**Amendments to the Drawings:**

## **REMARKS**

### **Amendment To The Drawings**

FIG. 1

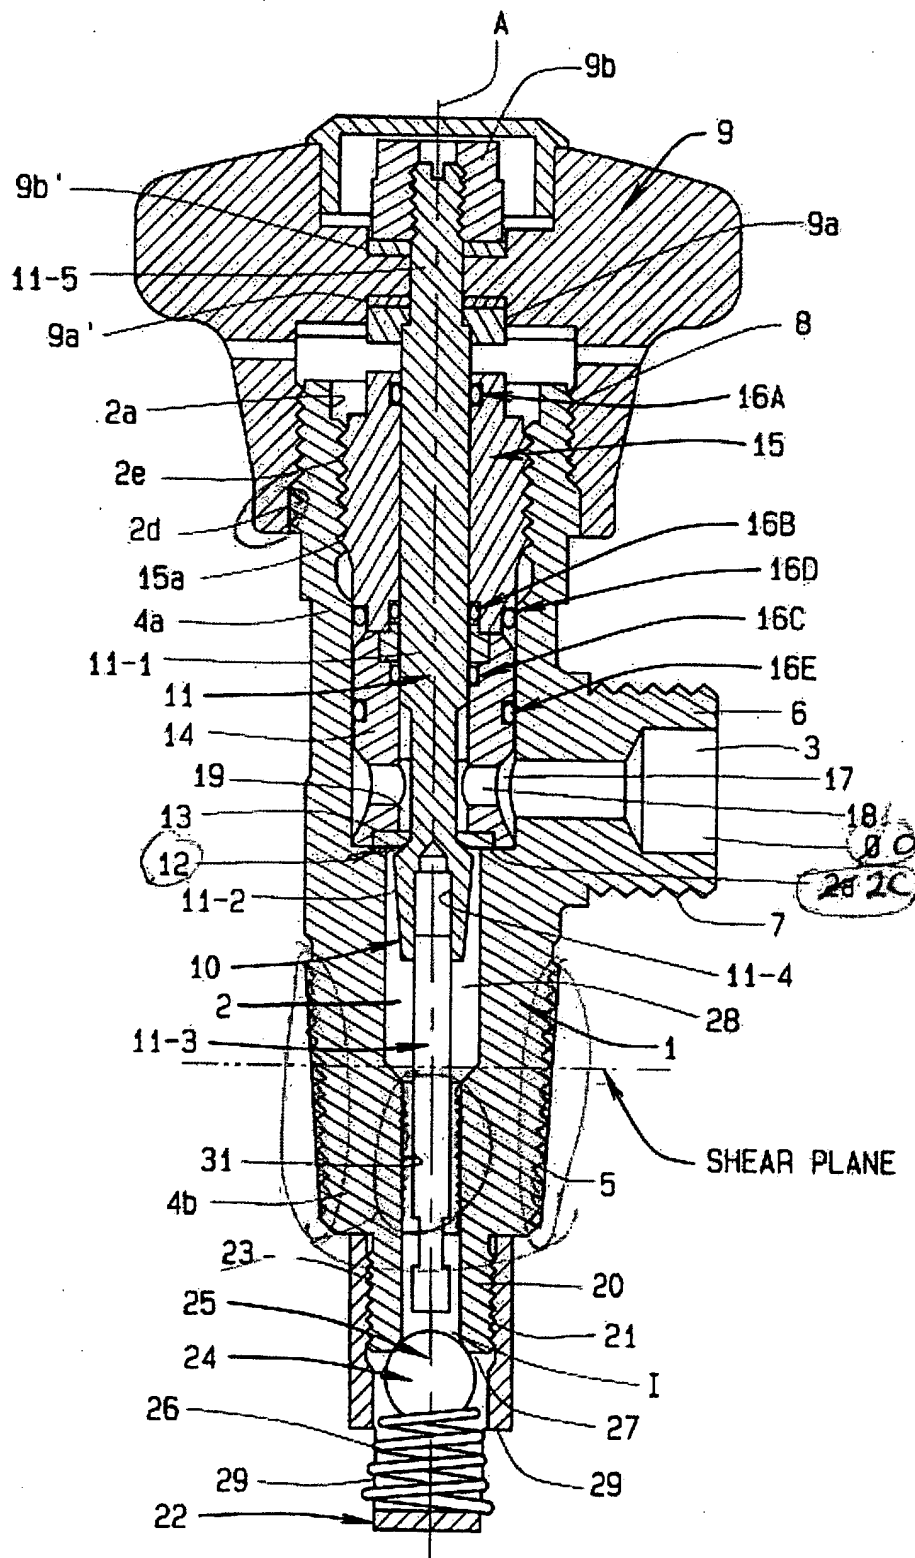
Upon review of the drawings filed with the prior amendment, Applicants' undersigned attorney noted discrepancies between the drawings filed and the original drawings filed with the application. The amendments to FIGS. 1 and 2 correct these errors. These corrections include typographical errors in the reference numbers and the correction of lines which should have been shown as threaded, but were shown as straight lines. The changes to the drawings do not add new matter to the application.

FIG. 2

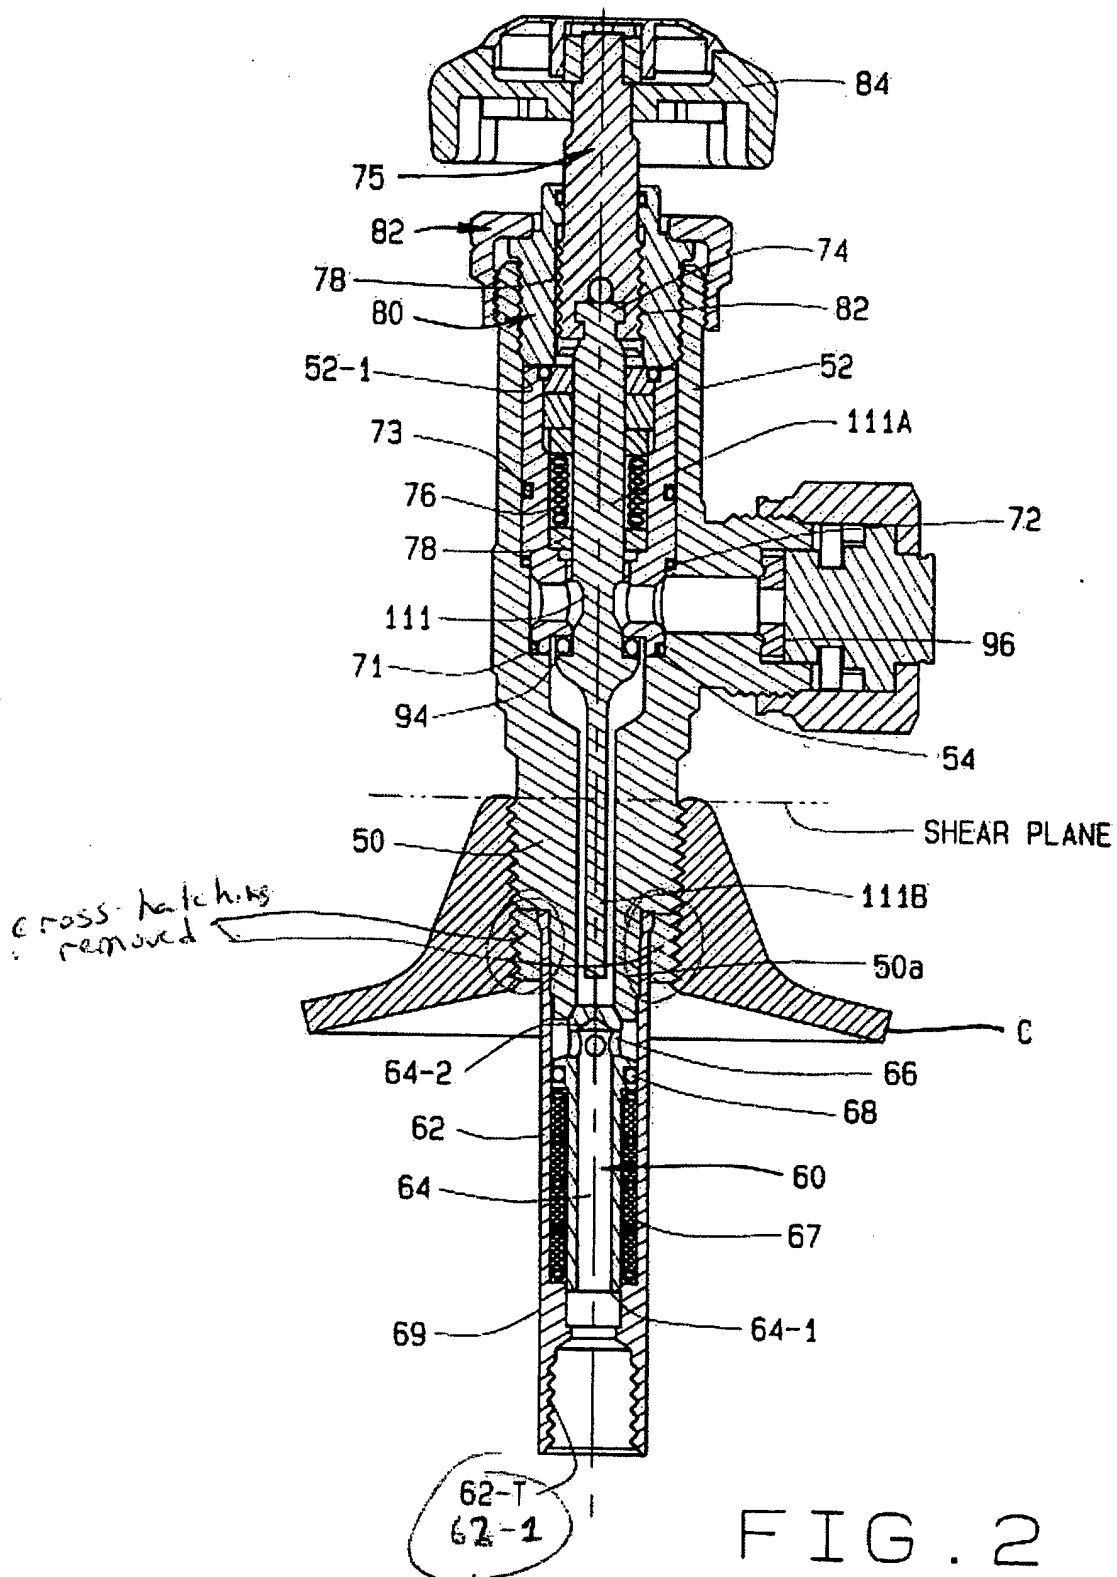
The specification has been amended, as noted above, to provide support in the specification for claim language that was inserted in the prior amendment. In particular, paragraph [0032] has been amended to provide that the terms "retention member", and "piston head" are alternative names for the sleeve tube 62 and the closed upper end 64-2 of the piston element 64. In addition, the tubular piston element 64 is defined as having "a piston skirt" with a lower open end 64-1. These elements can all be seen in FIG. 2, and thus do not add new matter to the application.

New Claim 24 has been added. New Claim 24 depends from Claim 17 and provides that "a sealing ring is disposed in an annular groove of the outer annular flange of the piston element." The sealing ring is shown in FIG. 2 in the groove of flange 68 as described at the end of amended paragraph [0032]. Inasmuch as Claim 24 includes subject matter that is readily seen from the drawings, new Claim 24 does not add new matter to the application. Claim 24 is believed to be allowable in view of its dependence from Claim 17.
